ALERT SERVICE BULLETIN

NO. 412-01-108

MODEL AFFECTED: 412/412EP

SUBJECT: CHIP DETECTOR ASSEMBLY, TEDECO B3703

FIGURE 1

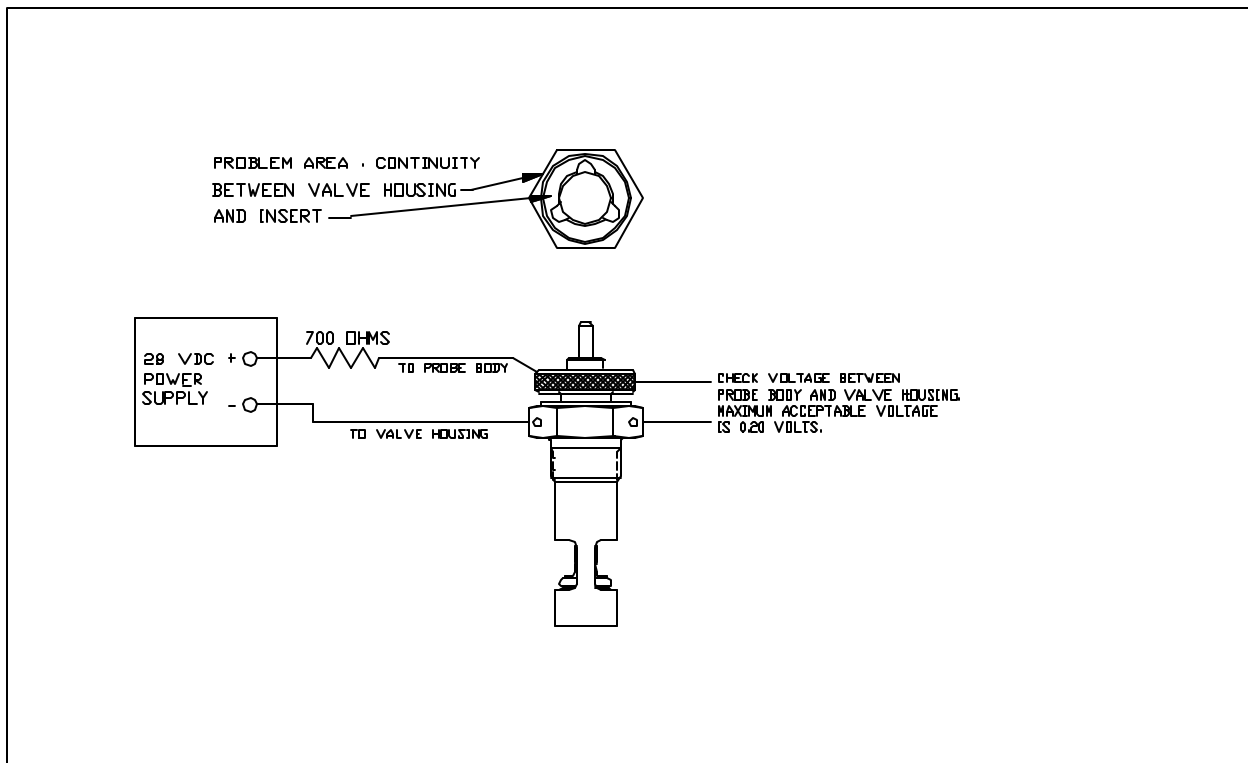
1. Connect the chip detector to a 28 Volt DC power supply using a 700 ohm, 2 watt resistor as shown in Figure 1.
2. Measure the voltage between the probe body and the valve body. The voltage drop must be 0.20 volts or less across the unit. If the voltage drop is larger than 0.20 volts, then return the unit to Tedeco (See 3. Part Replacement.)

FIGURE 2

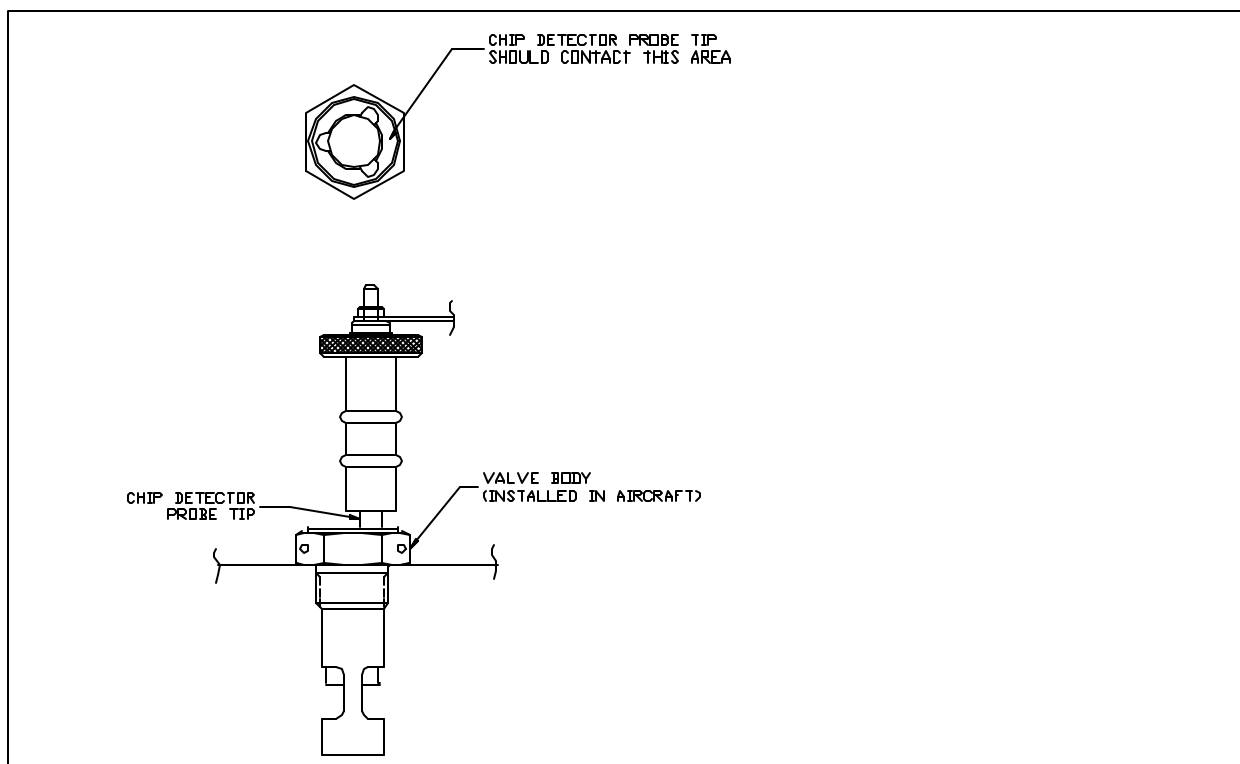
1. Ensure that electrical power is supplied to the chip detector.
2. Remove the chip detector probe from the self-closing valve.
3. Hold the tip of the center stud of the chip detector probe firmly against the steel insert as shown in Figure 2 while checking chip indicator light in cockpit. If the cockpit light illuminates, the unit is acceptable. If the light does not illuminate, then proceed to the next step.

FIGURE 3

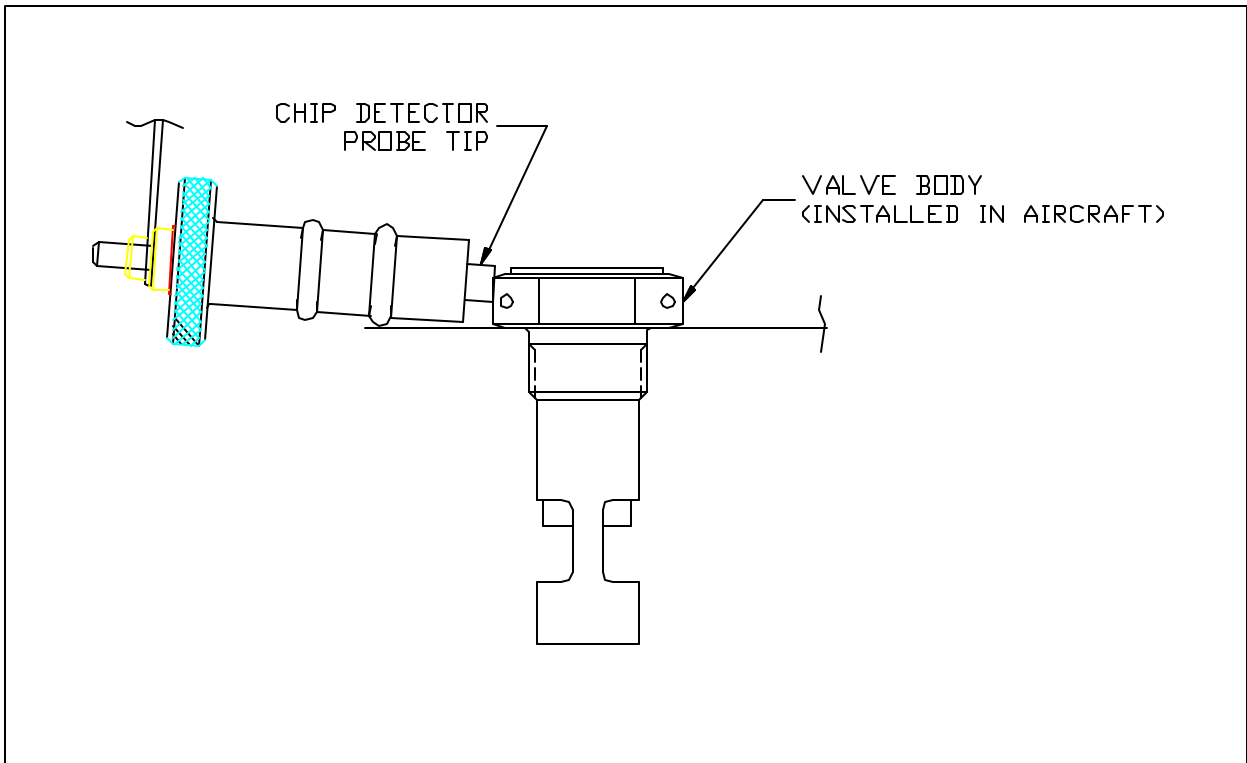
4. Hold the tip of the center stud of the chip detector probe firmly against the valve housing as shown in Figure 3 while checking chip indicator light in cockpit. The cockpit light should illuminate. Illumination of the light in this step isolates the electrical discontinuity to the valve insert. Repair the unit per the repair instructions in section 2 of this document.

FIGURE 4A

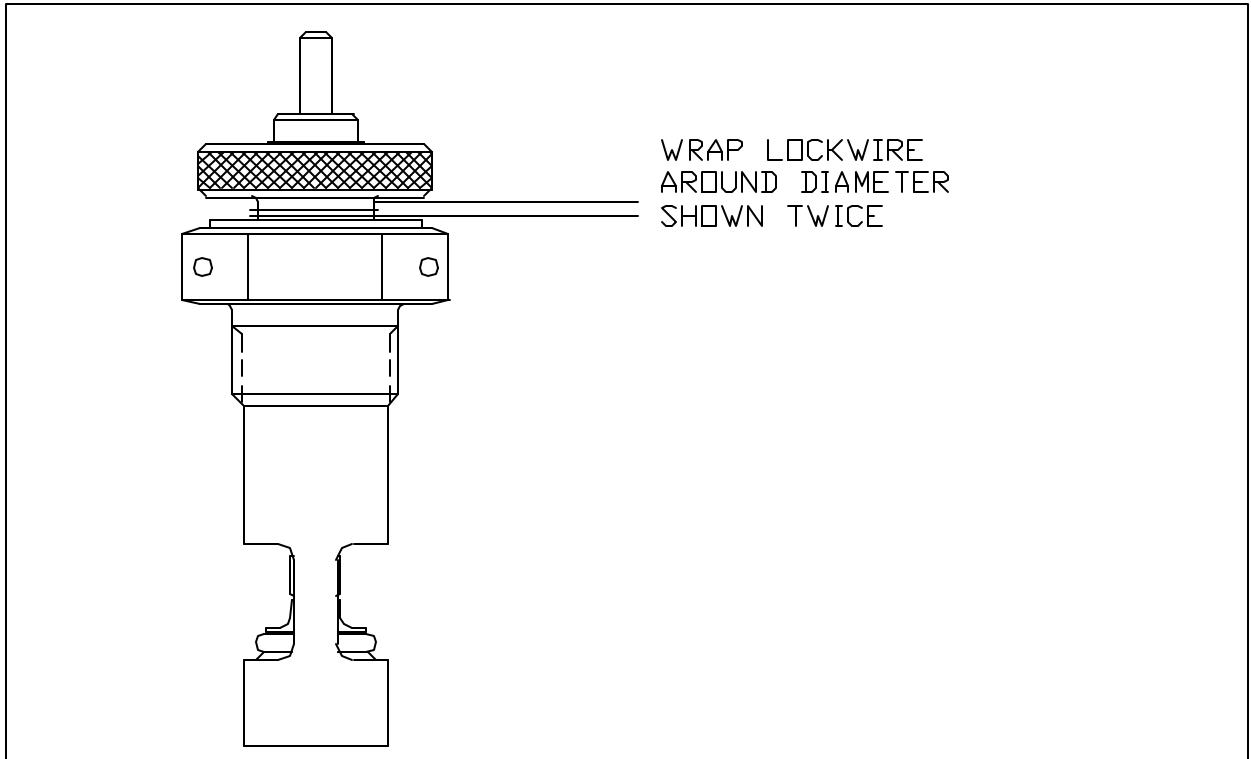
- 2.1. Install Chip Detector Probe into Valve assembly.
- 2.2. Tightly wrap a piece of lockwire (approx 6 inch length) around the chip detector probe diameter shown two full times. (See Figure 4A.)

FIGURE 4B

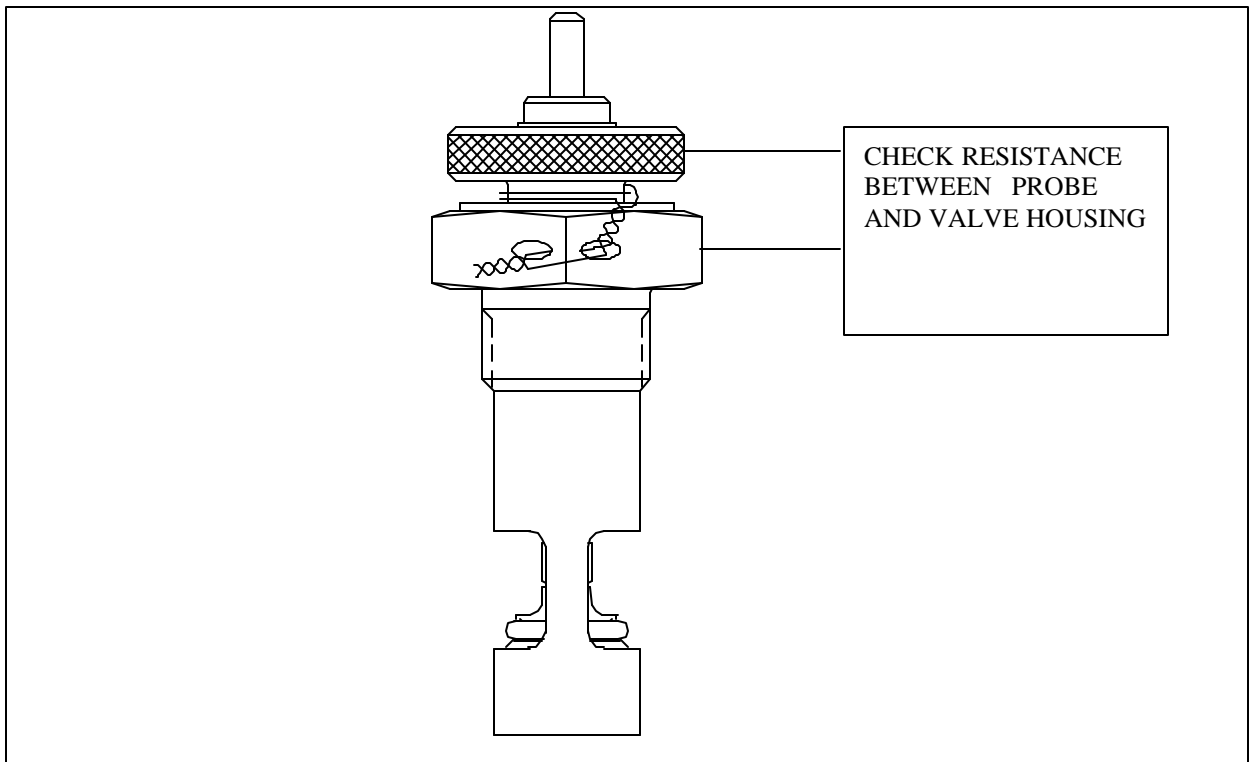
- 2.3. Twist two ends together approximately five times until twisted section reaches nearest free lockwire hole. Ensure that lockwire is tightly wrapped.
- 2.4. Slide one end of lockwire through the lockwire hole. Continue twisting two ends together to complete the lockwiring. (See Figure 4B.)
- 2.5. Check repair by using an ohmmeter to check resistance between the chip detector probe and the valve housing. Resistance should be 1 ohm maximum. (See Figure 4B.)
